2016 SITE 8 AND SUQITUGHNEQ RIVER SURFACE WATER AND SEDIMENT SAMPLING REPORT

NORTHEAST CAPE ST. LAWRENCE ISLAND, ALASKA

FUDS No. F10AK0969-03

**Final
September 2017**

FIGURE NO:
A-2

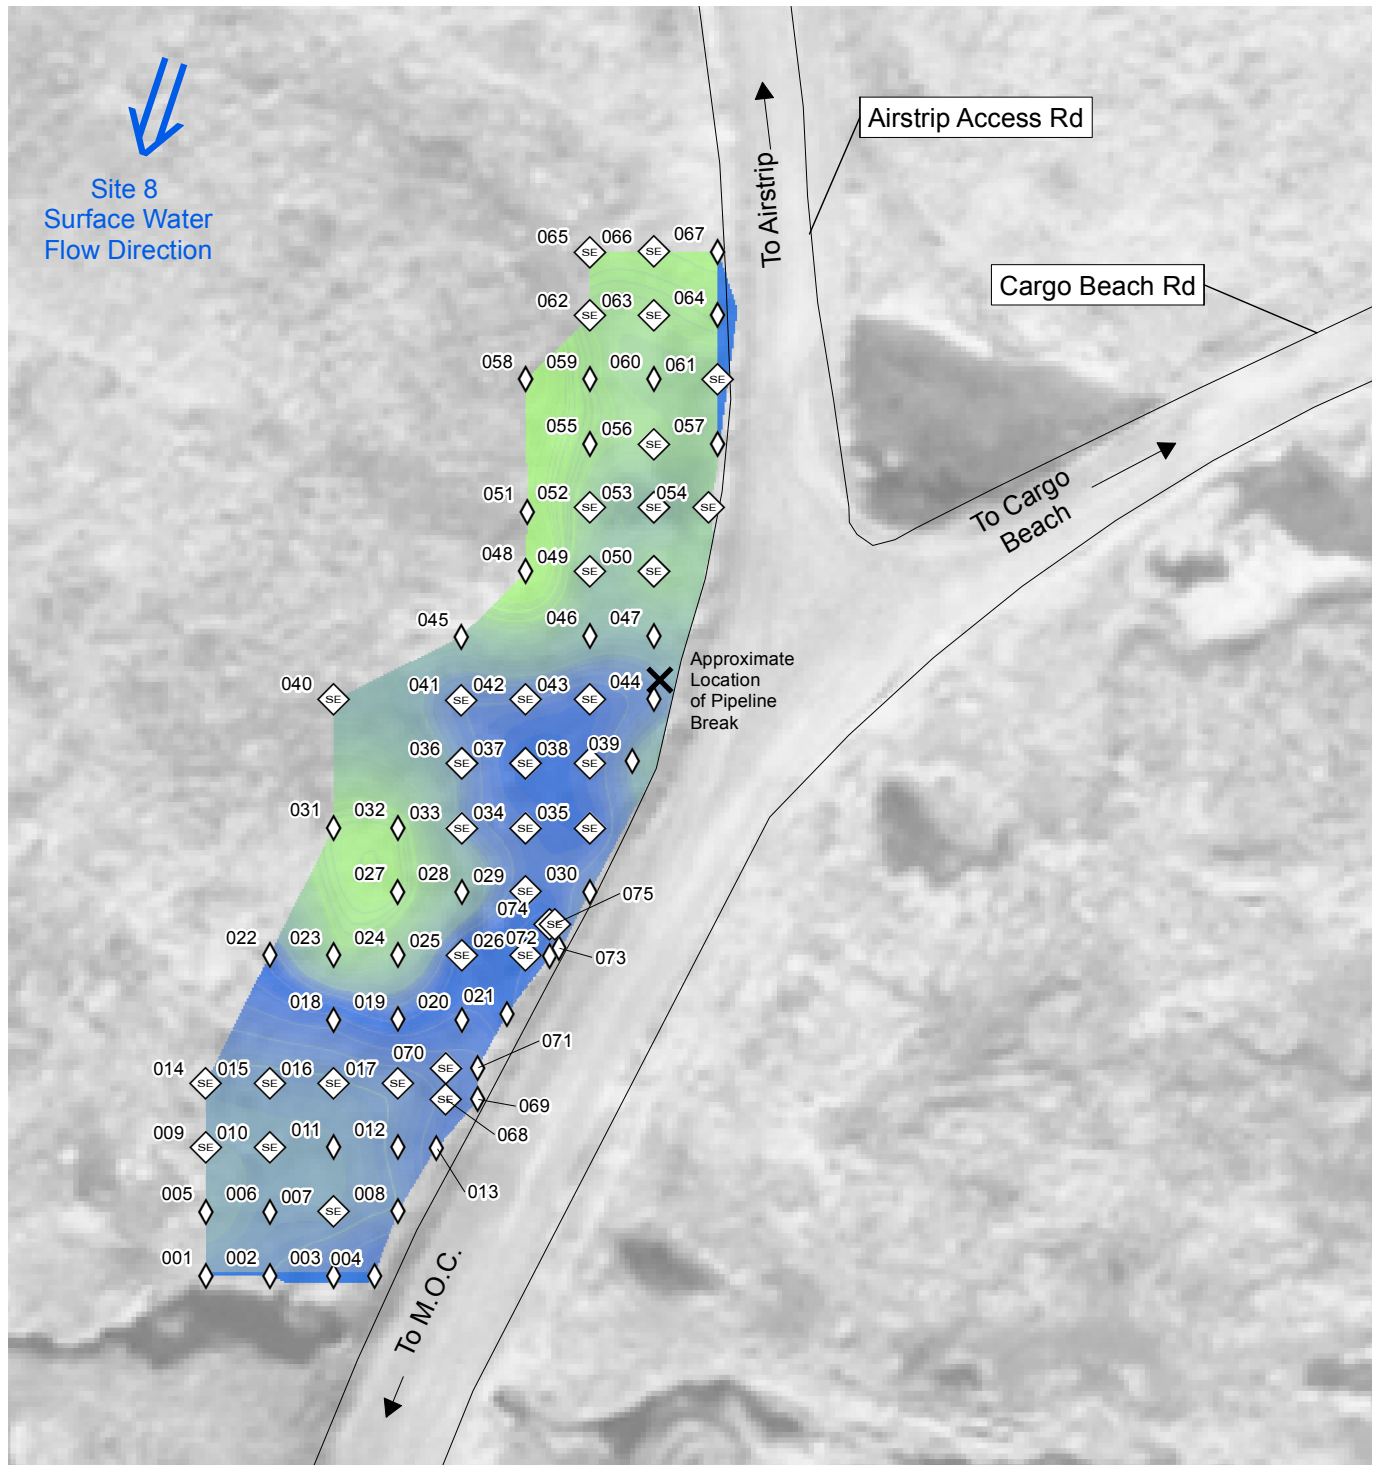
#	Page #	Section	ADEC Comment	Response
32.		Figure A-2	Please include AOC boundaries and/or call out IDs on this and all applicable figures for all of the NEC sites; i.e. Site 28 Drainage Basin, Site 21, roofing tar area, etc.	Accepted. AOC polygons will be added to Figures A-2 (similar to Figure A-2 of the LTMP), A-5, A-6.1, A-6.2, and A-6.3 and labeled as “ <i>Remediation Site</i> ”. ADEC-Accepted August 24, 2017

FIGURE NO:
A-3

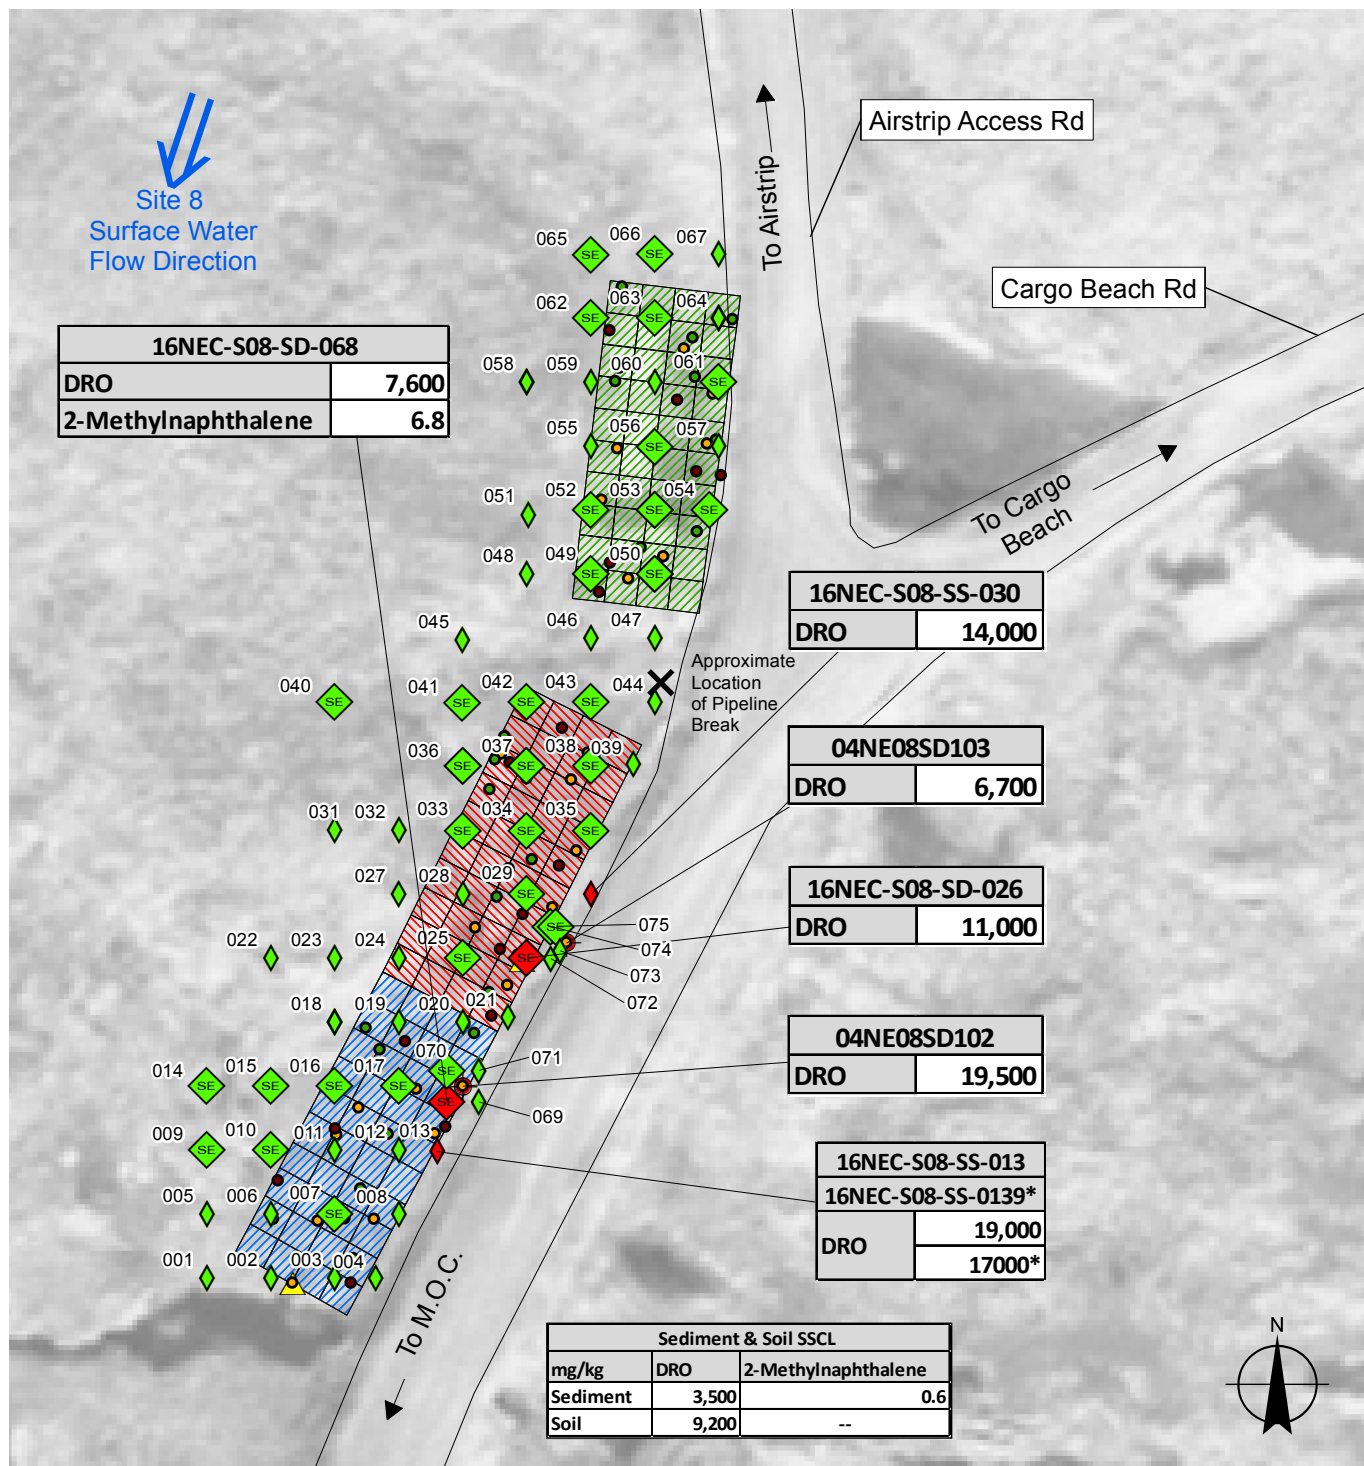
33.		Figure A-3	<p>Please revise/replace references to ‘local’ and ‘regional’ groundwater flow direction and actually state the name of the site and/or ‘general site wide’ respectively to avoid confusion.</p> <p>Please include applicable date(s) in all figure titles and legend entries, actions, etc. Please apply this revision for all applicable figures.</p> <p>Also revise the title by inserting ‘...Surface Soil [Samples] At...’ and also add a figure note to clarify that these samples were designated sediment or soil based on field and sample observation at the time of</p>	<p>Accepted. Additional errors were noted. Figures A-3 and A-4 will include “<i>Site 8 Surface Water Flow Direction</i>”. Figures A-5, A-6.1, A-6.2, and A-6.3 will include “<i>General Site Wide Groundwater Flow Direction</i>”. ADEC-Accepted August 24, 2017</p> <p>Accepted. Figures will be revised to include 2016 as appropriate. Figure A-2 legend will be revised to include “<i>2016 Area of Interest</i>”. Figure A-3 title will be revised to include “<i>2016 Distribution of Sediment and Surface Soil Samples at Site 8</i>”. Figure A-4 title will be revised to state “<i>2016 Site 8 Sediment and Surface Soil Exceedances</i>”. Figure A-5 title will be revised to state “<i>2016 Suqitughneq River Surface Water & Sediment Exceedances</i>”. Figures A-6.1 through A-6.3 title will be revised to state “<i>2016 Suqitughneq River Cross Sections</i>”. ADEC-Accepted August 24, 2017</p> <p>Legends will be revised to include sample year. ADEC-Accepted August 24, 2017</p> <p>Accepted. See response to comment above. A note will be added to state: “<i>Samples designated as sediment or soil based on field observations at the</i></p>

FIGURE NO:
A-4

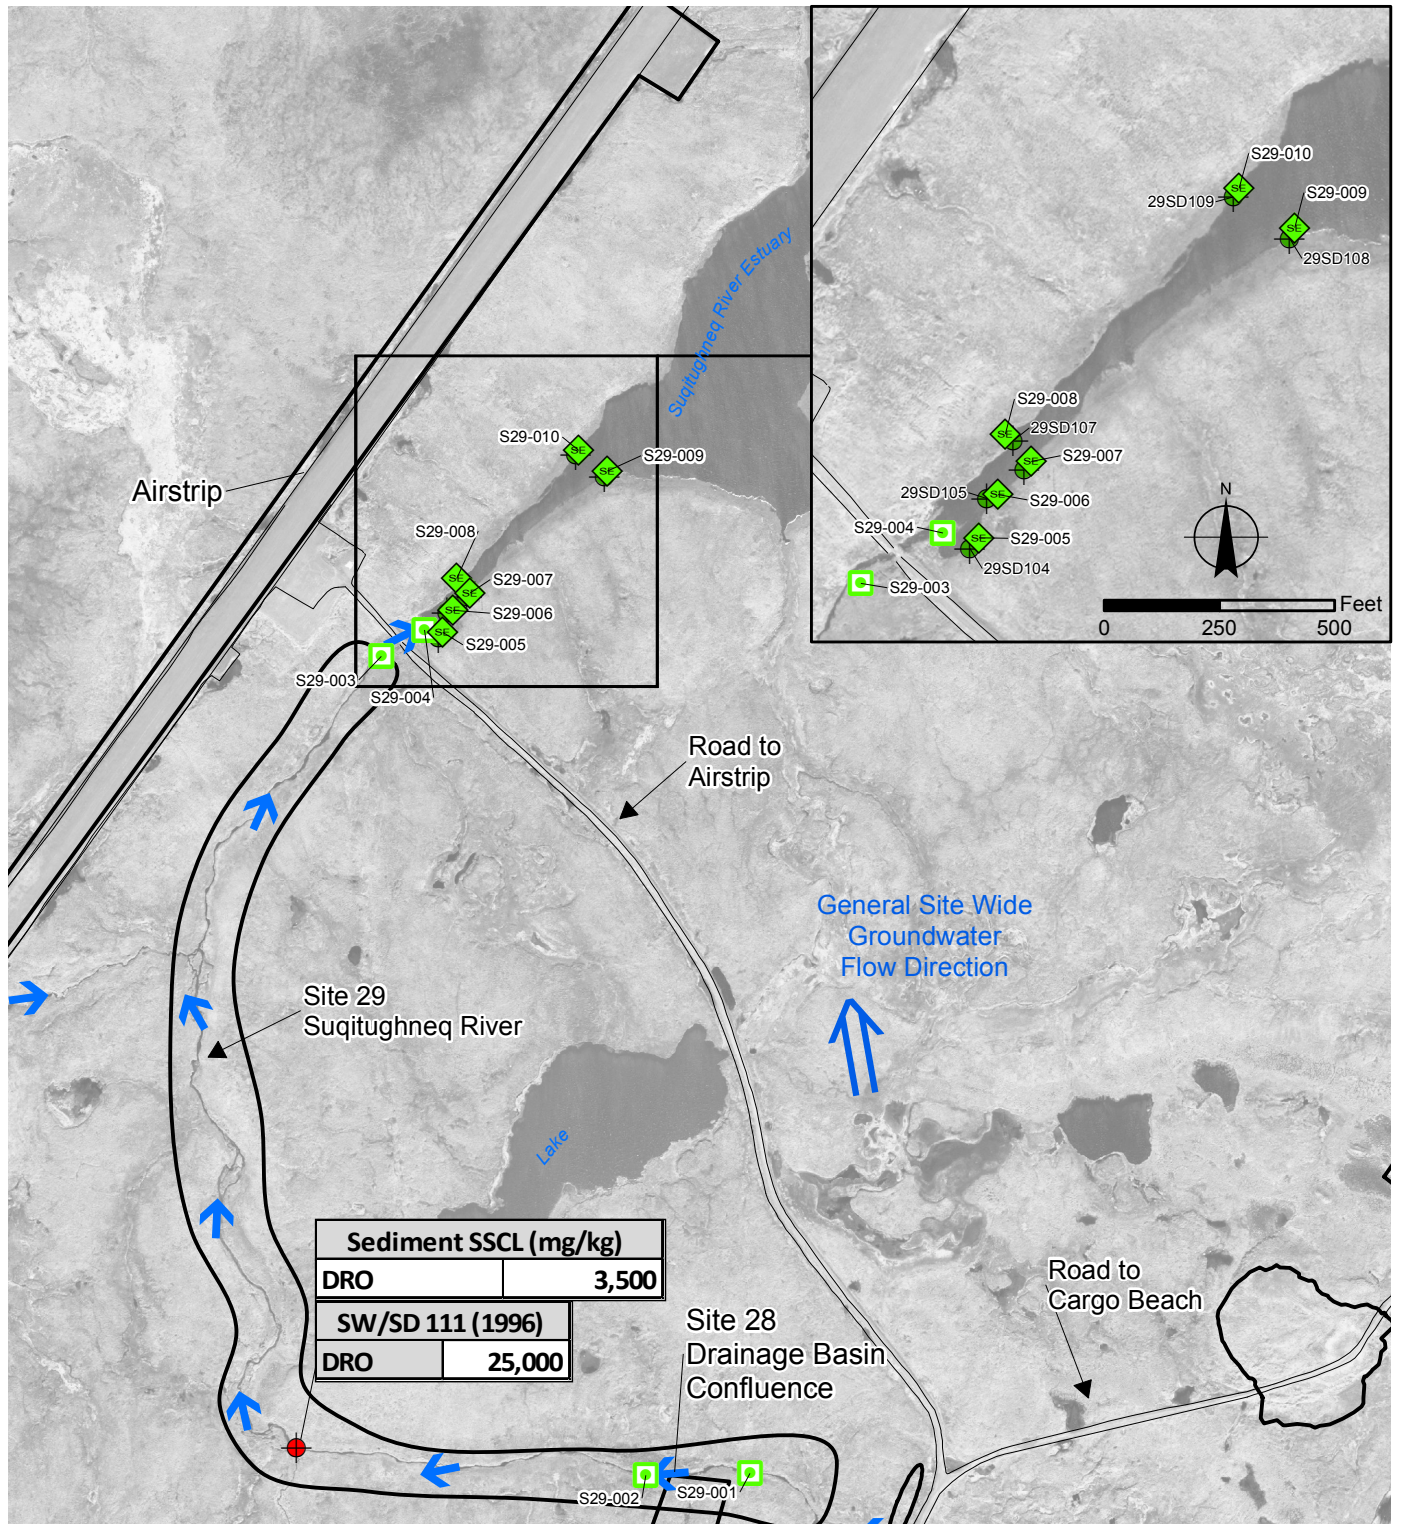
34.		Figure A-4	<p>Please include dates for all actions in the legend. Please also include a figure note as well as detail in the respective applicable sections that states the sample depths, range of depths, etc. The respective narrative sections should also discuss any limitations that sample depths may have on adequately characterizing the overall extent of contamination at the site and associated migration pathways.</p> <p>Figure A-4 has a lot of good information, however ADEC recommends adding a new figure that depicts the boundary of the extent of site investigation to date (i.e. 2016 if that is the furthest horizontal extent to date), and then to depict all of sample locations for all matrices where respective cleanup level exceedances were observed (i.e. as red with different shapes similar to Figure A-4) but then to do the same for all locations where notable concentrations were detected however were below respective cleanup levels (i.e. in yellow) and exclude the insignificant detections/non-detects. This would provide a better CSM for evaluation of the fate and transport concerns. Please clarify if all of the prior samples associated with sediment were delineated/considered sediment; noting that the pre-2016 samples indicated in the legend are all 'sediment and surface water'.</p>	<p>Accepted in part. Legend will be revised to include "2016" before all 2016 sample results and historical sediment exceedance will be revised to state "2004".</p> <p>ADEC-Accepted August 24, 2017</p> <p>A note will be added to state: "<i>Sediment and soil sample depths ranged from 0.5 feet to 2.5 feet below ground surface</i>". Sample depths are discussed in the first paragraph of Section 5.2.1. Samples were collected in accordance with the WP; no visual contamination was noted. ADEC-Accepted August 24, 2017</p> <p>The current Figures A-3 and A-4 depict the lateral extent of historical sampling at Site 8. While samples collected in 2016 were distinguished as sediment or soil, historical samples results were interchangeably referred to as sediment or soil and would make the requested assessment difficult to complete.</p> <p>ADEC - Tentatively Accepted August 24, 2017; per agreed upon revisions/ amendments to the report that were discussed/concurred by the project team during the August 10, 2017 comment resolution meeting.</p> <p>See response to comment #33 for Figures A-3 and A-4 title revision.</p> <p>ADEC-Accepted August 24, 2017</p>

FIGURE NO:
A-5

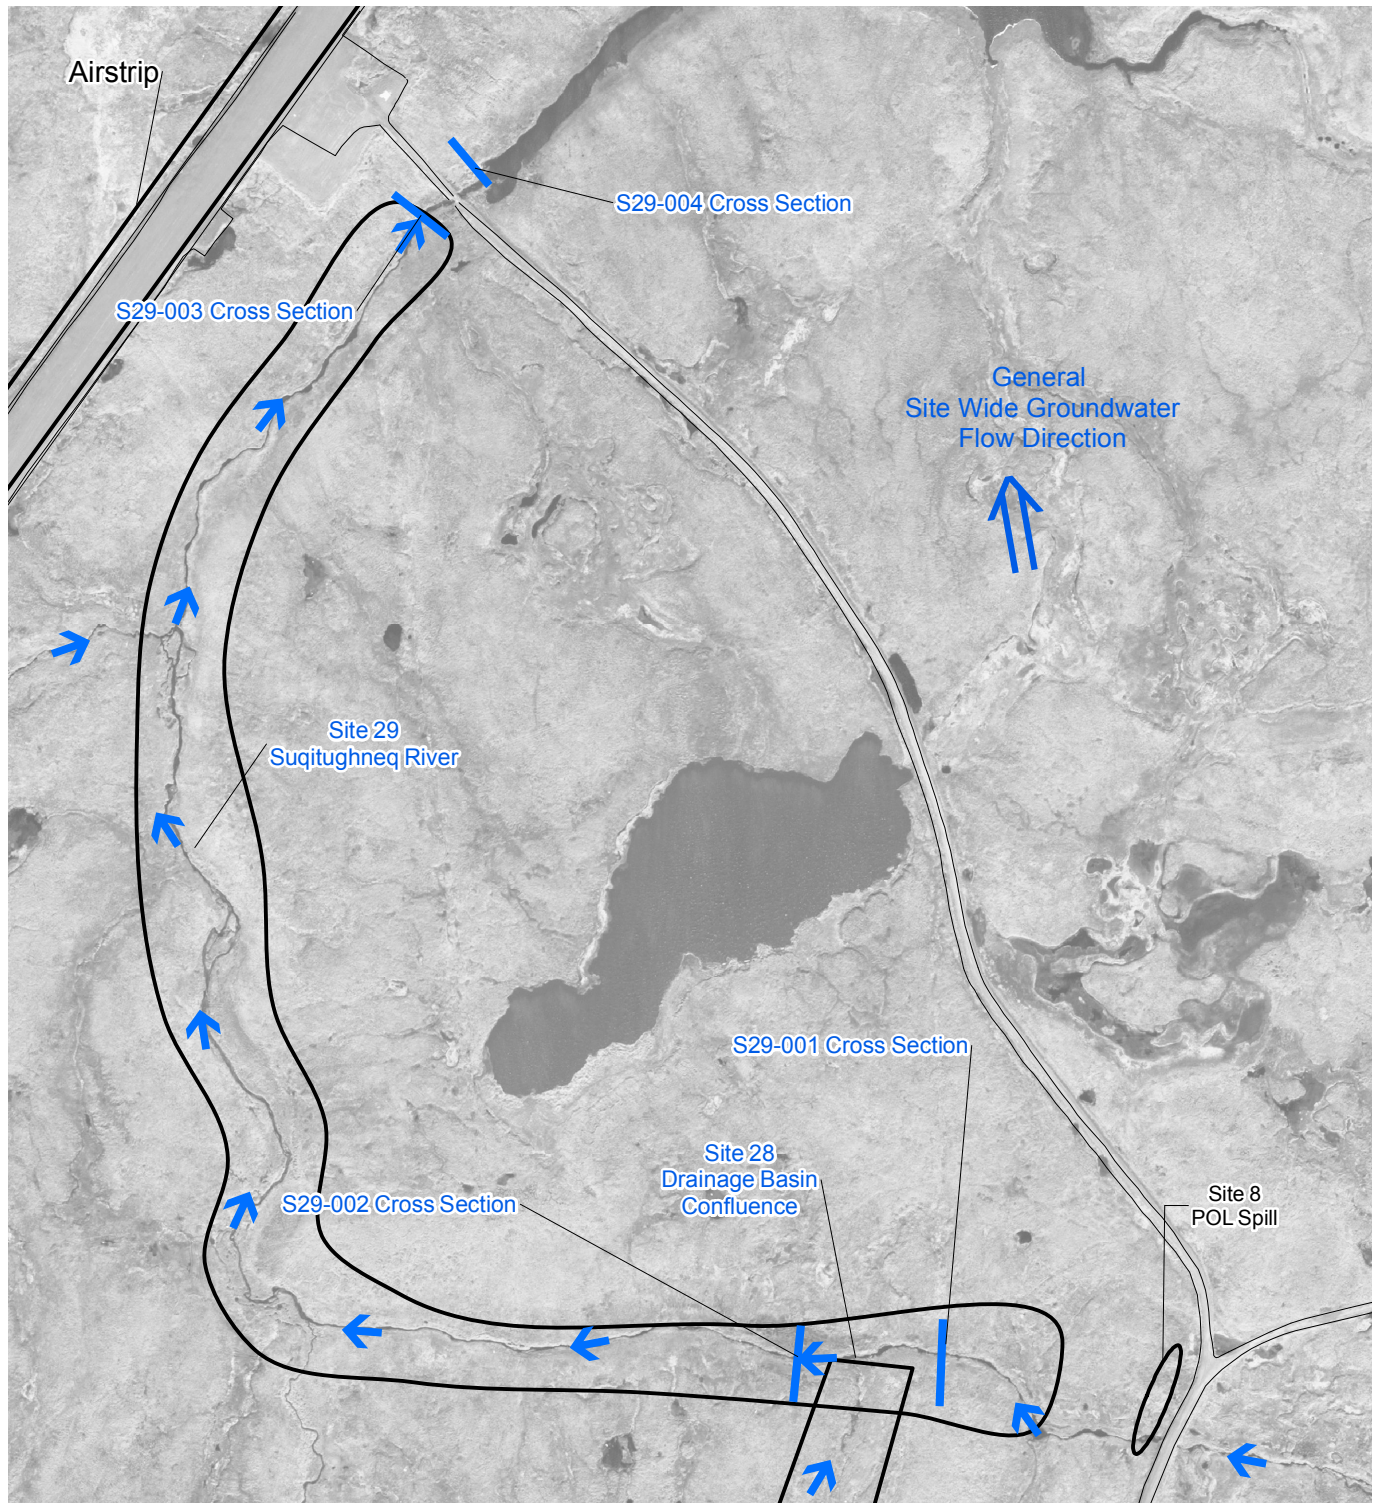
35.		Figure A-5	<p>Please apply all applicable comments on other figures above to this figure.</p> <p>Recommend revising ‘regional’ to ‘Suqi River Drainage Basin’ for the groundwater flow direction.</p> <p>Similar to the Site 8 depictions of analyses results, the Suqi results need to be depicted and evaluated based on ranges of concentrations and not just exceedances/non-exceedances since these areas are being evaluated for fate and transport concerns and not just whether an exceedance is observed at a specific location at a point in time.</p>	<p>Accepted. Title will be revised; see response to comment #33. The historical sediment samples in the legend will be revised to state the sample year. ADEC-Accepted August 24, 2017</p> <p>Accepted in part. Flow arrow label will state “<i>General Site Wide Groundwater Flow Direction</i>”. See response to comment #33. ADEC-Accepted August 24, 2017</p> <p>Accepted. Ranges of concentrations will be presented. See response to comment #3. ADEC-Accepted August 24, 2017; per responses to RTC #3.</p> <p>Discuss during comment resolution meeting. The intent of sampling at the Suqi River was to determine whether the remedial activities at Site 28 impacted the Suqi River by revisiting previous sampling locations and comparing historical results to the 2016 results. ADEC-Accepted August 24, 2017</p>
